ADDENDUM NO. 1

EXIT 2 AREA WATER SYSTEM IMPROVEMENTS
Town of Salem
Salem, New Hampshire

April 22, 2016

Addendum #1
SKC-01
Dwg. C-1
4/22/16

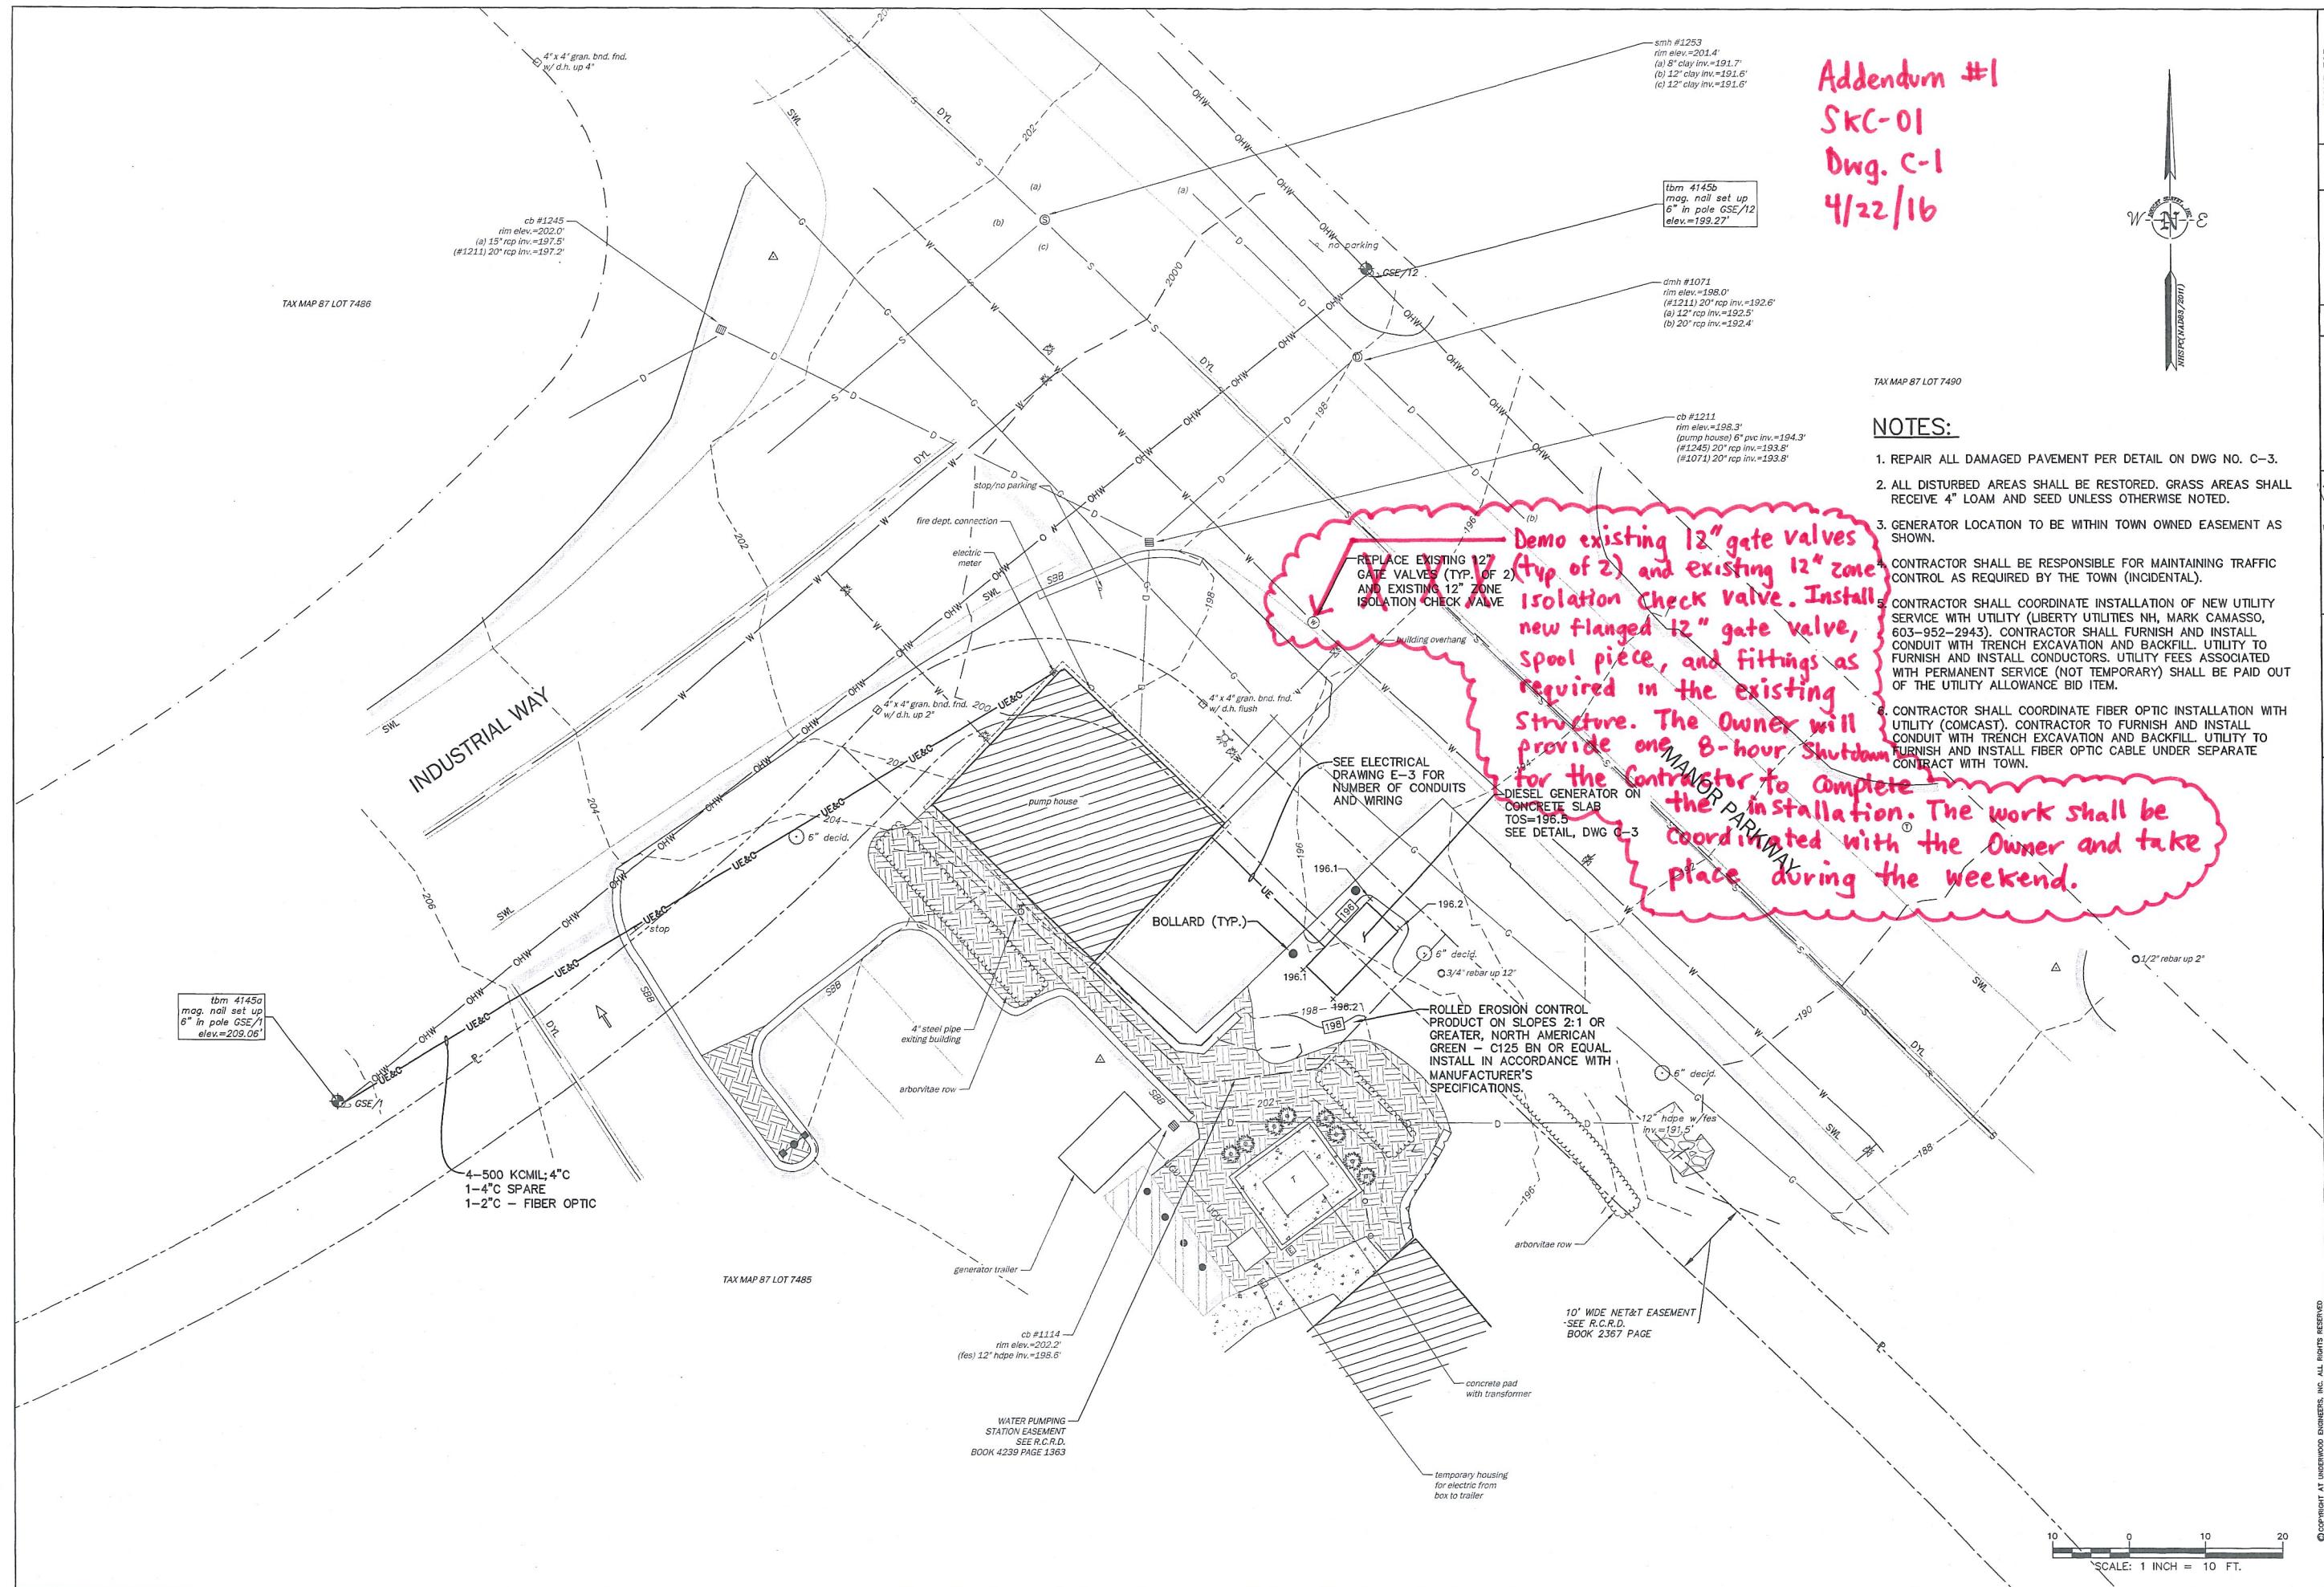
1. *Dwg No. C-1, Sheet 3 of 24, Manor Parkway Pumping Station Site Plan.*
 - Revise per the attached sketch SKC-01.
2. *Dwg No. C-2, Sheet 4 of 24, Commercial Drive Pumping Station Site Plan.*
 - Revise per the attached sketch SKC-02.
3. *Dwg No. C-5, Sheet 7 of 24, Water Details.*
 - Revise per the attached sketch SKC-03.
4. *Dwg No. P-3, Sheet 16 of 24, Commercial Dr. Pumping Station Process Plan.*
 - Delete note 4 entirely.
5. *Dwg No. E-3, Sheet 24 of 24, Electrical Details.*
 - Revise per the attached sketch SKE-01.

Q3: **Reference drawing C-1. Please indicate a location for the two 12" gate valves, and a location and a spec. for the 12" zone isolation check valve to be replaced.**

Q7: **Reference drawing C-1. Are the gate valves and check valve to be replaced in the existing water manhole flanged fittings or MJ? Will the Town shutoff and isolate the main at this location for the Contractor to do the work?**

A3: *The gate valves and the isolation check valve are located in the existing water manhole as shown on C-1. The zone isolation valve is a silent non-slam check valve specified in 15100-3. [Please note that since responding to this question, the scope of work for the existing manhole has been modified as identified in this Addendum].*

A7: *Please see the attached photograph that shows the inside of the existing water manhole structure. [Please note that since responding to this question, the scope of work for the existing manhole has been modified as identified in this Addendum].*

Addendum #1
SKC-03
DWG. C-5
4/22/16

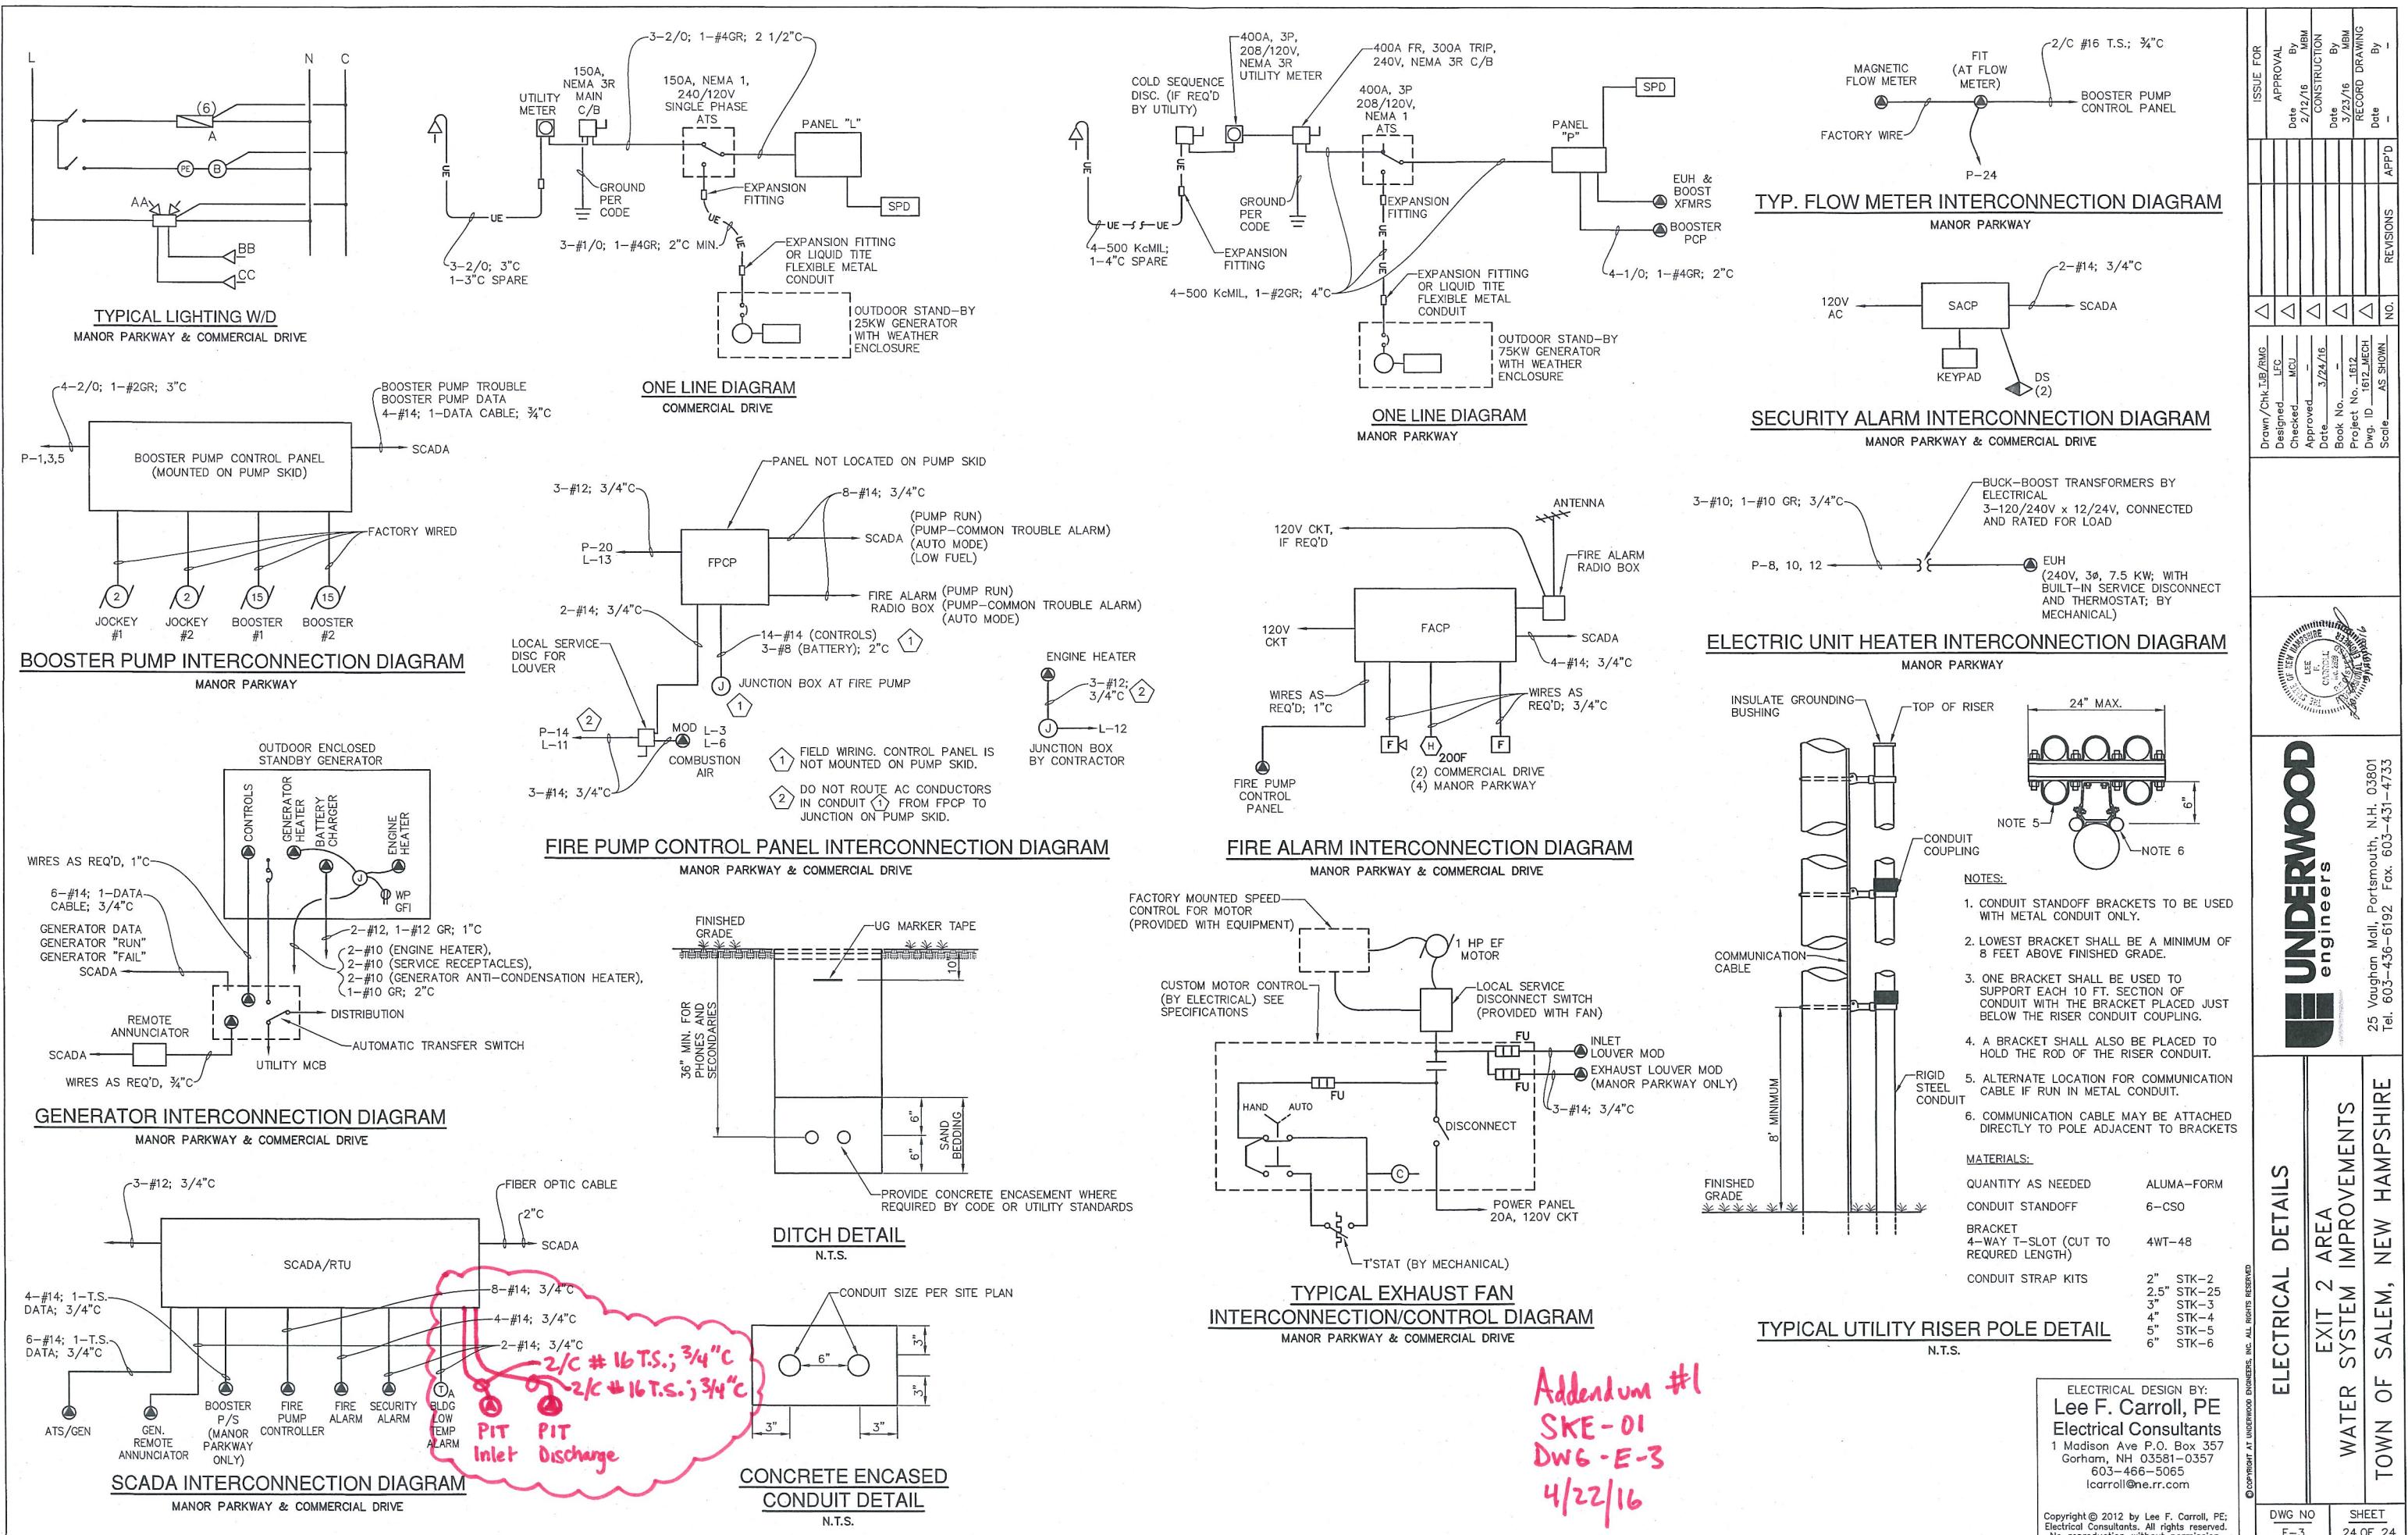
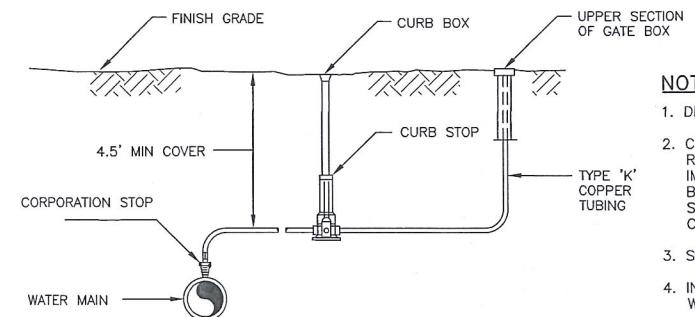
Q4: **Reference drawings C-2 and C-5. Please clarify the piping going in and out of the 6 ft. water manhole (6" vs. 12" check valve and 8" vs. 12" gate valves).**

A4: *An addendum will be issued to clarify pipe and valve sizes at the 6 ft. water manhole.*
